APPENDIX R

Comments on the Draft EIS and Responses

20190705-5164 FERC PDF (Unofficial) 7/5/2019 1:53:21 PM

Figure 1: American Indian and Alaska Native population share for census tracts located in the project area. Tracts outlined in yellow appear to have been omitted from EJSSCREEN and other analyses for the PCGP.

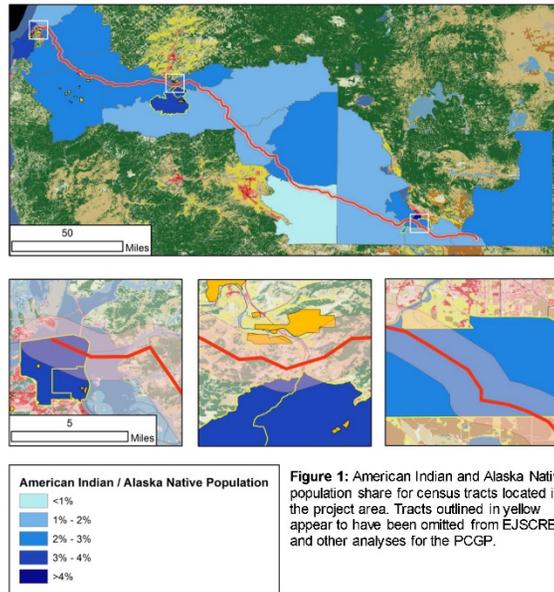
The pipeline route also appears to come within one mile of three additional tracts, Coos County Tract 3, and Douglas County Tracts 1900 and 2000. FERC has used a one-mile buffer to define census tract study areas for other recent pipeline projects,²² and it is unclear why a similar buffer was not employed here. More precise GIS data would be necessary to confirm whether these census tracts should be included in the analysis. Figure 1 shows the general pipeline route (extracted manually from the applicant's website) with missing tracts outlined in yellow.

An improved EJ analysis should discuss the high and adverse impacts in light of the disproportionality ratio or some other disparity metric. The analysis should also incorporate any census tracts omitted from the original list of those used by the agency or applicant (e.g. Figure 1).

CO26-93 Section 4.9.2.9 has been expanded in the final EIS and now identifies the census tracts that were included in the environmental justice analysis for the Pipeline (see new table 4.9.2.9-3). Census tracts considered in this analysis are those that would either be crossed by or are within 1 mile of the proposed route.
